**MAP ACCURACY REPORT**  
**Countywide Imagery & DEM**  
**Crow Wing County**

<b>Data Contact Person:</b>	Don Sigety, LS	<b>Department:</b>	County Surveyor
<b>Type of Mapping:</b>	DEM (LiDAR) & Ortho	<b>Contractor:</b>	Merrick & Company
<b>Independent Testing:</b>	Mn/DOT Photo Unit	<b>Contract Delivery date:</b>	2 April 2008

**Project Identification:** Crow Wing County Digital Elevation Model and Orthophoto

# New location needed?

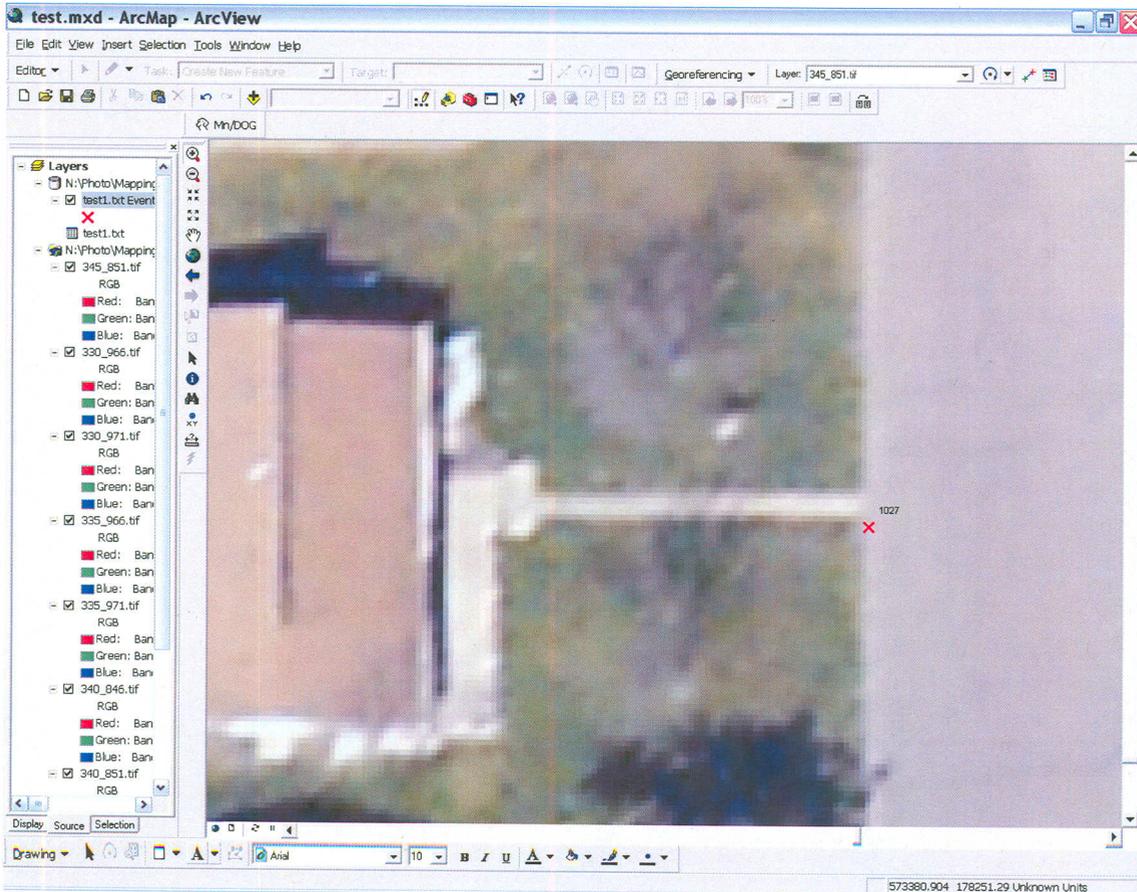
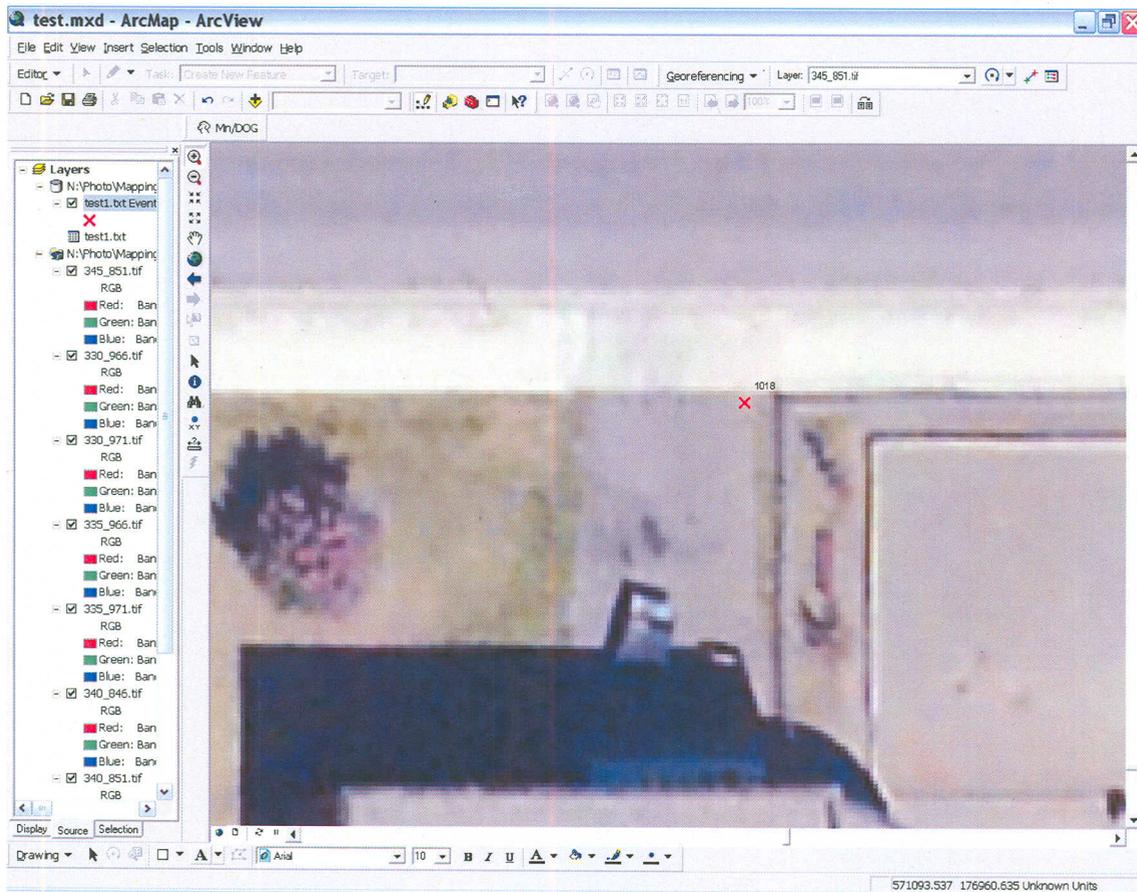
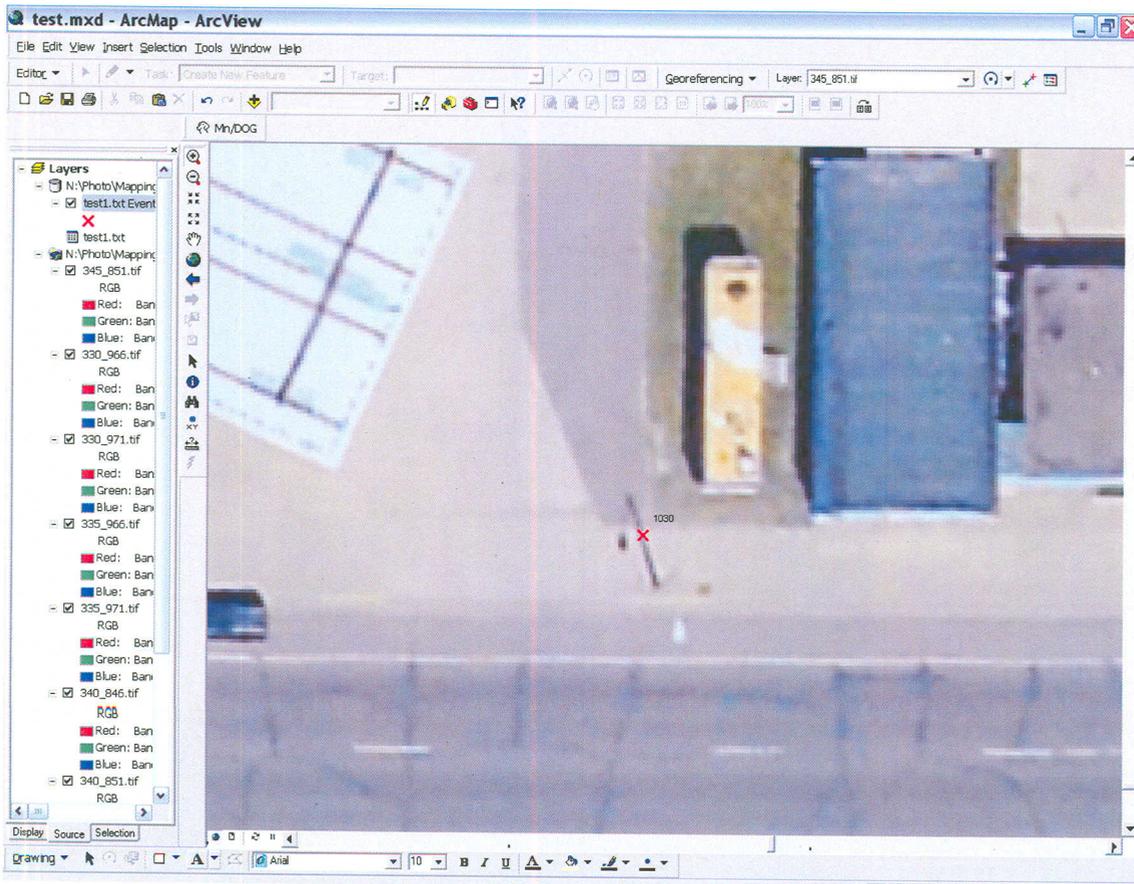
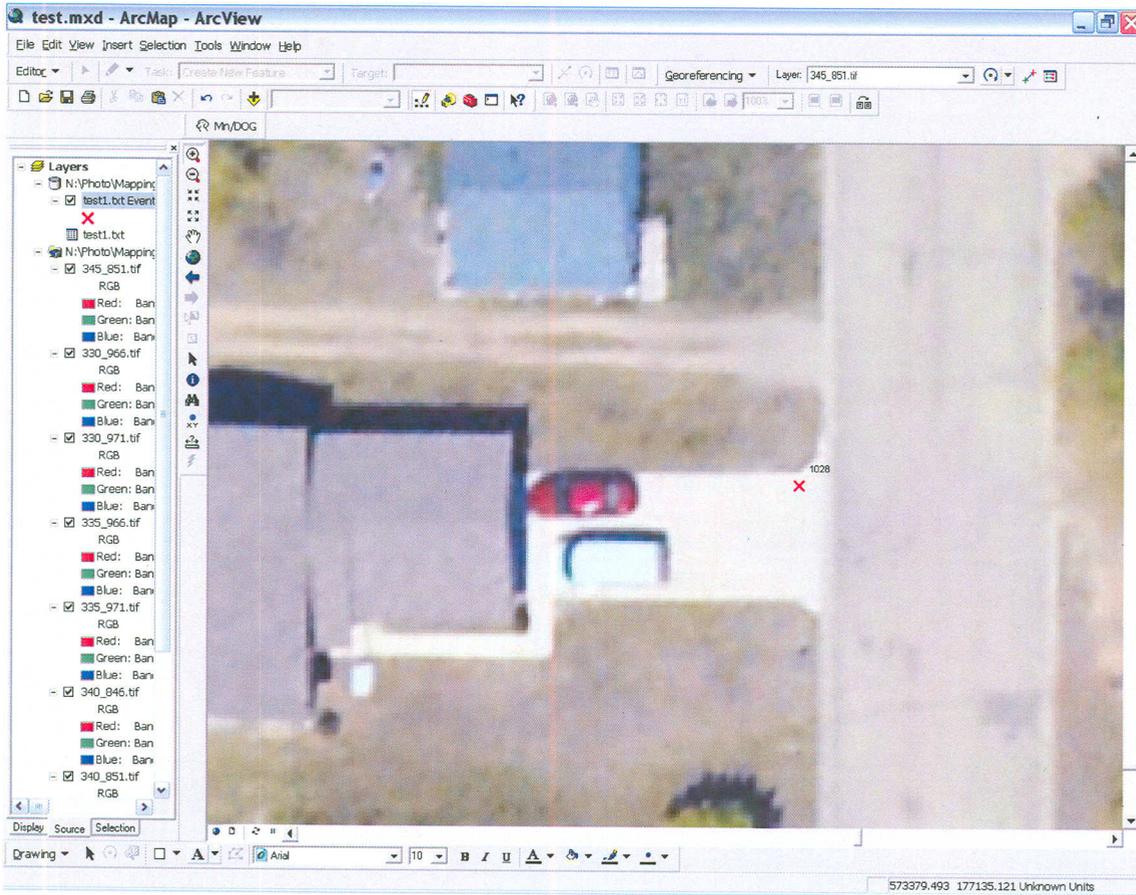
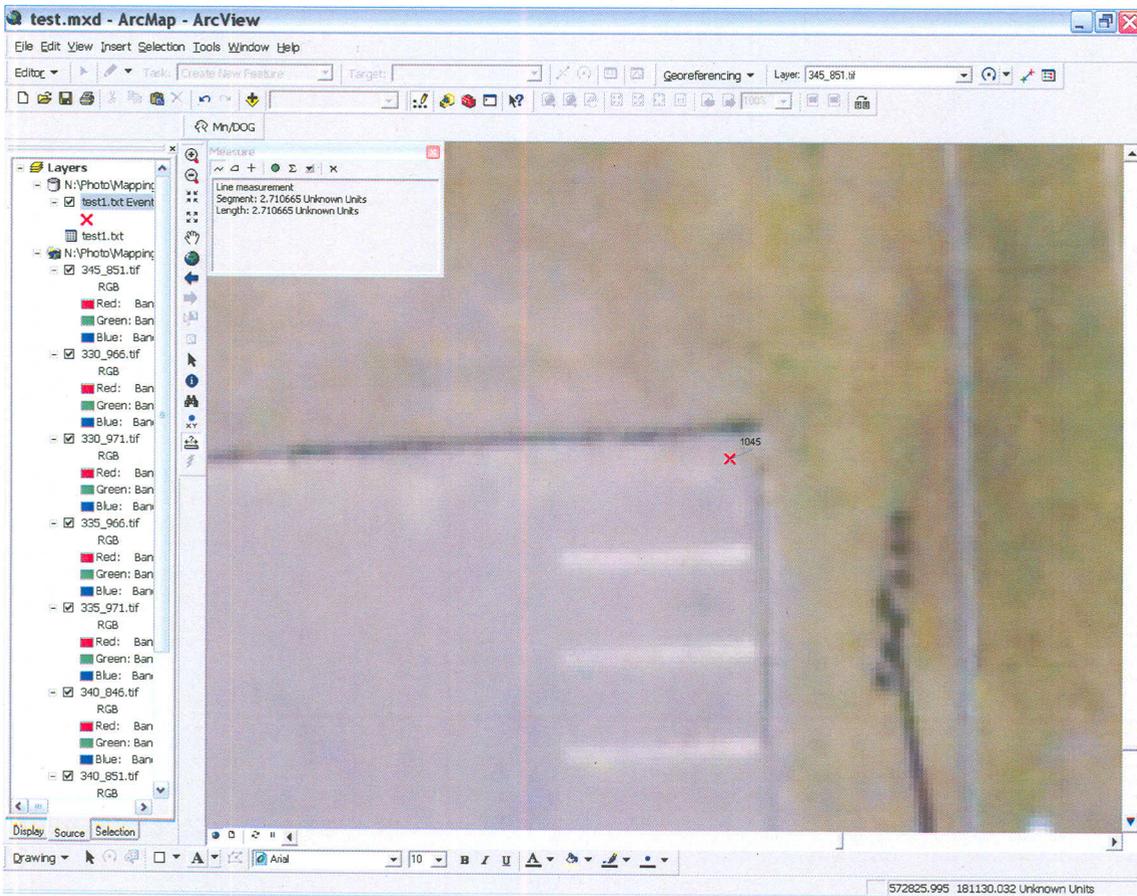
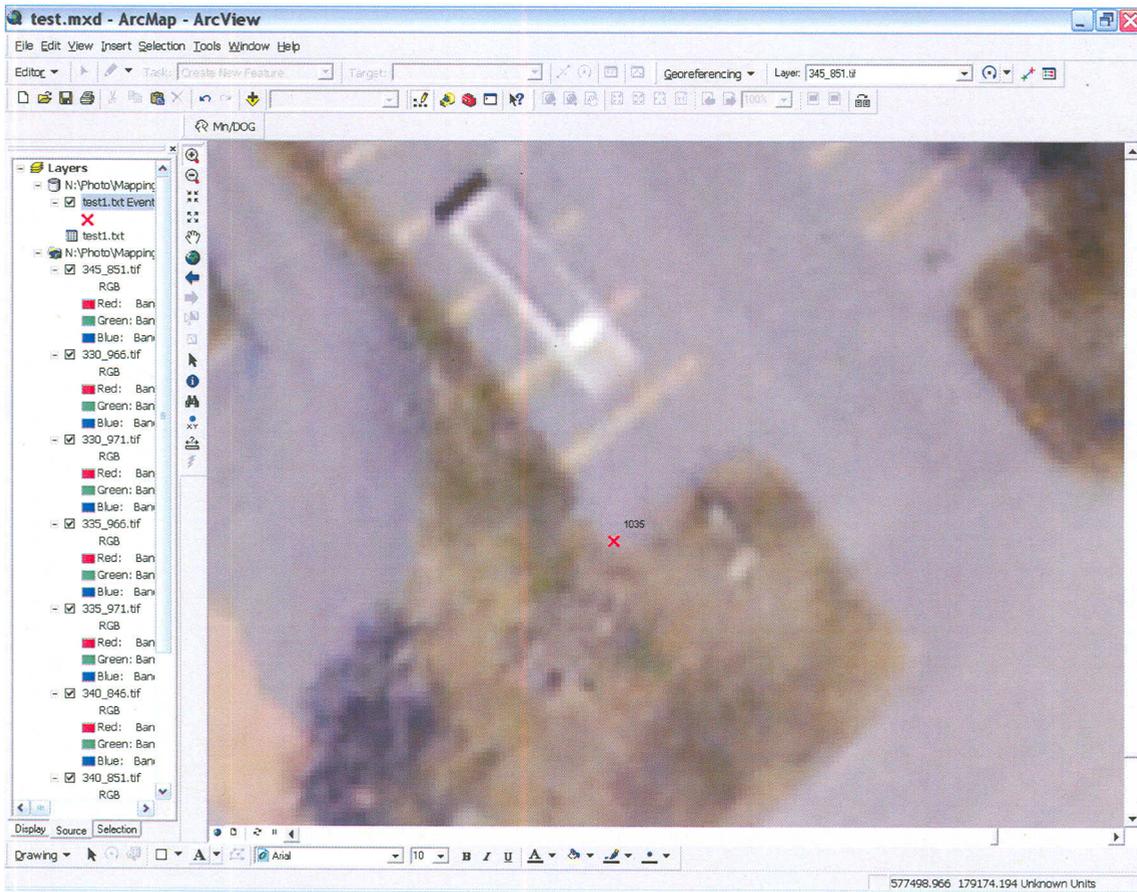
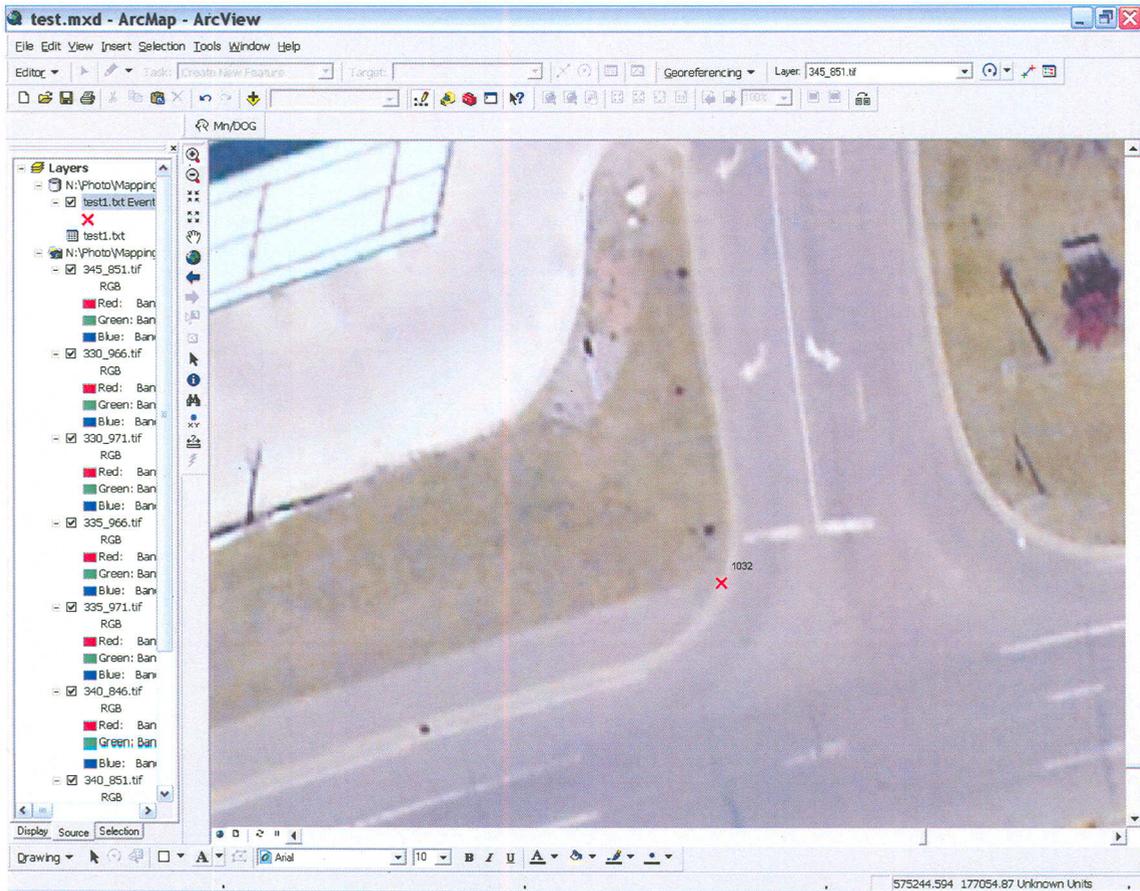
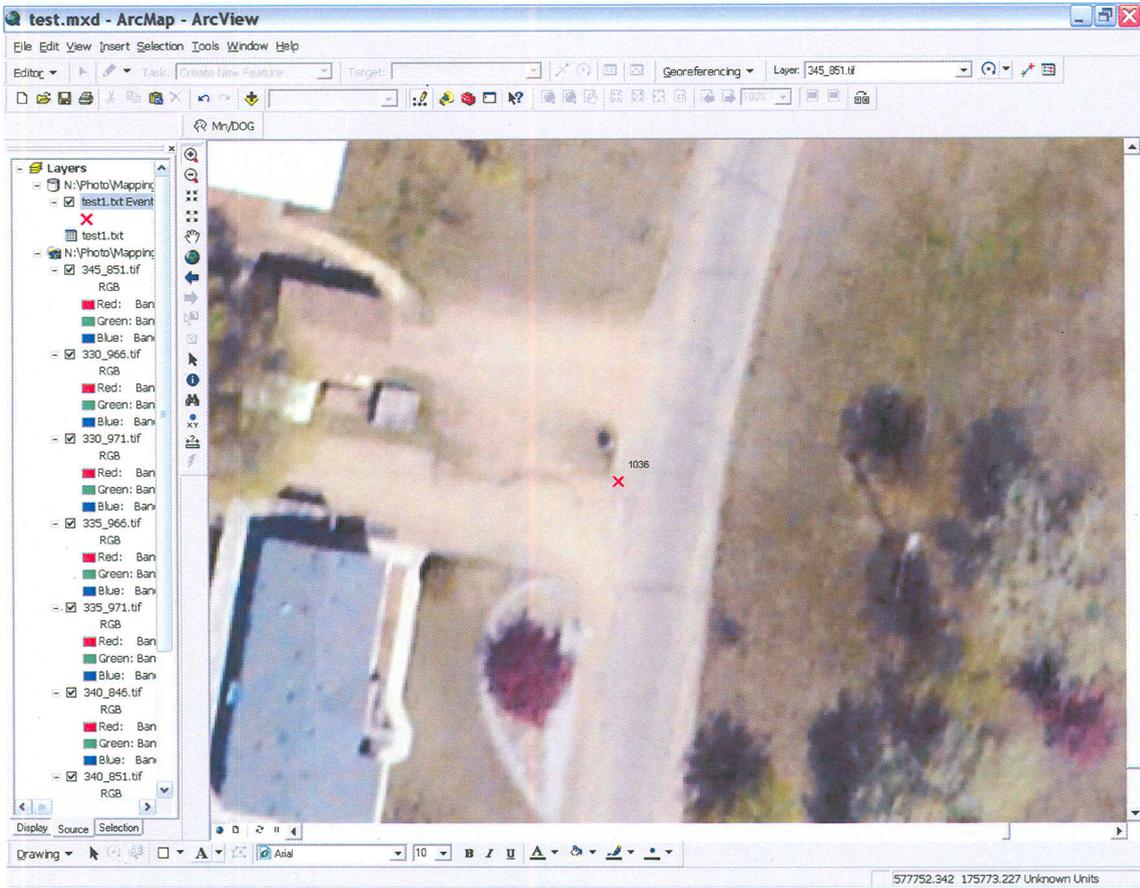
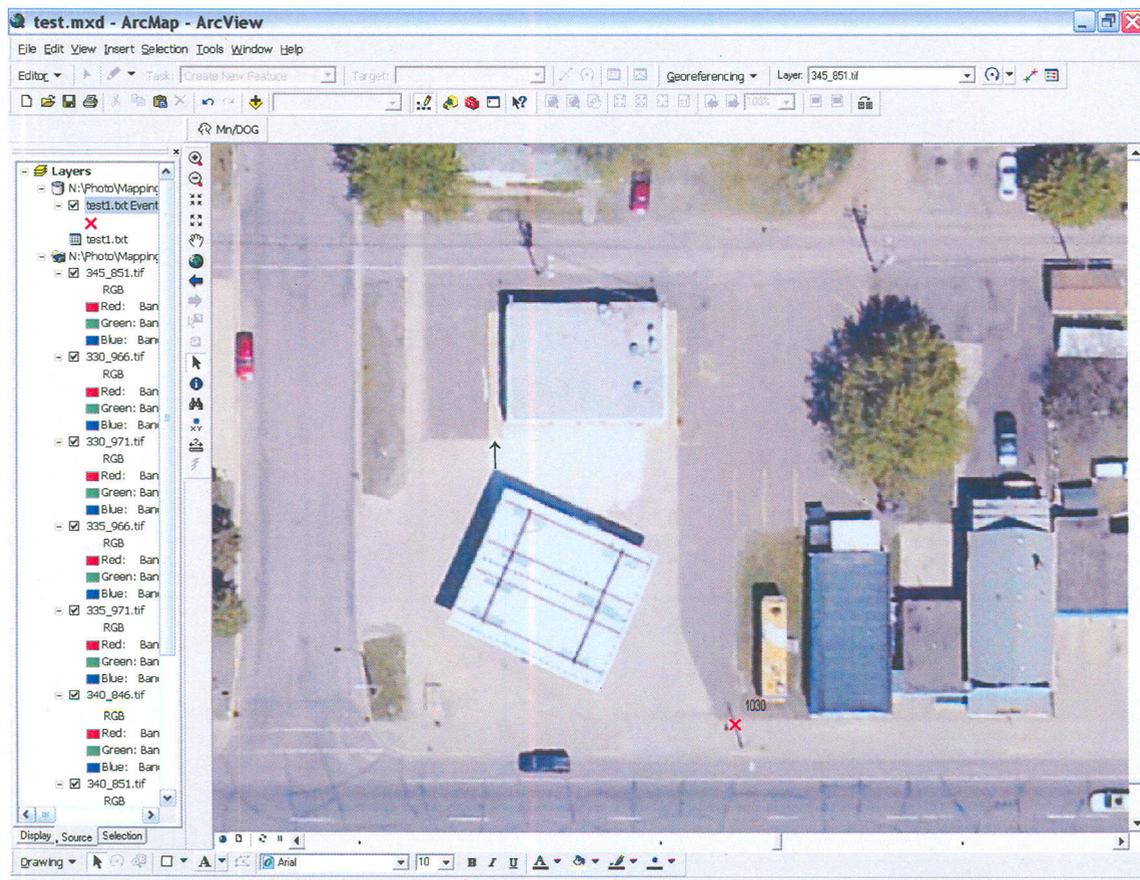
After reviewing the test points and imagery, I have decided that we need to change the location of some of the test shots and some may need to be double stubbed. Attached is a Word document containing screen shots showing the areas where I came up with high residuals or could not make out the exact spot the survey crew shot. The first three images in the word document show points that may need double stubbing. The contrast is good on the image, but the points appear off. The next five images show points where I could not tell what the survey crew shot. The last five images are suggestions of what they could shoot, that show good distinct corners and have good contrast in the photography. I understand that it is near to impossible for the survey crew to know what the camera is going to capture from the sky and that what they see on the ground may look good from 6 ft above but not from 1500 ft. I have also attached the horizontal test sheet so you can compare the screen shots to the test. If you have any questions let me know.
